# CHANGE ORDER

PROJECT:	Washoe County – Nevada Shared Radio System	CHANGE ORDER NO .:	8
		DATE:	09/22/2020
SELLER:	Harris Corporation Communication Systems Segment	CONTRACT DATE:	September 27, 2018
SELLER ADDRESS:	221 Jefferson Ridge Parkway Lynchburg, VA 24501

# Change Order No. 8 Detailed Description

Figure 23: Overall Microwave Topology

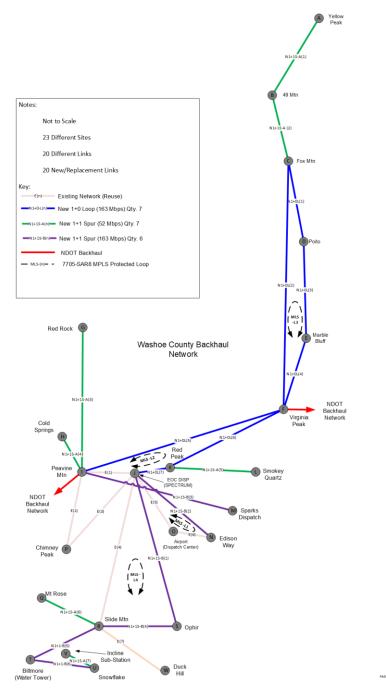
Harris will design and implement the new Washoe County microwave network that will provide highspeed wireless Ethernet transmission via the Nokia 7705 SAR-8 MPLS router installed at each Washoe County site. The new Washoe County microwave network will interconnect with the NDOT microwave network to form the NSRS backhaul. Harris will perform all services to implement all new equipment that includes microwave dishes, waveguide, radios, dehydrators, Network Management System and MPLS routers to provide network connectivity between the RF sites, cores, and existing PSAPs in Washoe County. Harris has reviewed the existing Comsearch Microwave Path Data Sheet provided by Washoe County and have used this data along with the selected RF sites in Washoe County to provide a microwave backhaul network solution that will interconnect to the NDOT microwave network which forms the NSRS. The new Washoe County microwave network solution comprises of 20 links which is a combination of loop-protected microwave links and monitor hot standby (MHSB) links. These links will interconnect the cores, RF sites and PSAPs to the NSRS. Each link will be designed with a path availability of 99.999% based on the receive threshold to provide the required link bandwidth.

The new Washoe County microwave network will include the Nokia 7705 SAR-8 MPLS routers for routing all packets between microwave sites, core locations and between NDOT and Washoe County microwave networks. In the event of a microwave path failure within a microwave loop, the 7705 SAR-8 will automatically reroute traffic to the opposite direction of the network. For RF sites that are connected by microwave spurs, a 1+1 MHSB radio will be installed to increase the reliability of the link. Harris has designed the microwave network based on the topology provided in Figure 23 below. The main microwave loop for interconnecting the two core sites in Washoe County consists of a 163 Mbps 1+1MHSB link with 7705 SAR08 MPLS backup loop protection using available bandwidth of existing links. The two cores are located at the EOC Dispatch and Edison Way locations. The northern loop and all spur sites will have links that support 52 Mbps radios. The Washoe County microwave network will interconnect with the NDOT microwave solution which share network nodes at Peavine Mtn and Virginia Peak site locations. Harris will coordinate with NDOT to support the routing of packets between the cores, RF sites and PSAPs located on the Washoe County side and the NDOT side of the NSRS.
